Product Change Notice (PCN)

PCN Number: **PCN-0451110R-01**

Product(s) Affected: **PJ-017D**

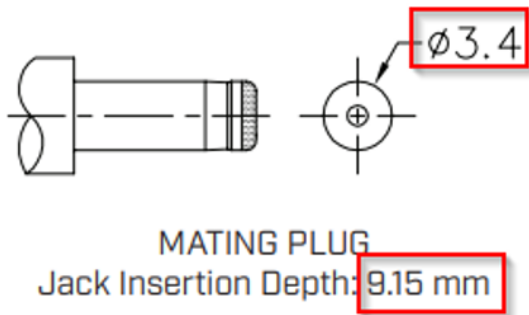
Description of Change: **Minor Housing and footprint differences. Material Change on the housing and terminals. See image Below**

PREVIOUS CUI DEVICES DETAIL / IMAGE			NEW CUI DEVICES DETAIL / IMAGE		
	MATERIAL	PLATING			
center pin	copper	nickel	DESCRIPTION	MATERIAL	PLATING/COLOR
terminal 1	brass	silver	center pin	brass	nickel
terminal 2	copper alloy	silver	terminal 1	brass t=0.40	silver
terminal 3	brass	silver	terminal 2	bronze t=0.30	silver
plastic	PBT		terminal 3	brass t=0.40	silver
			cover	PA9T [UL94V-0]	black
			housing	PA9T [UL94V-0]	black
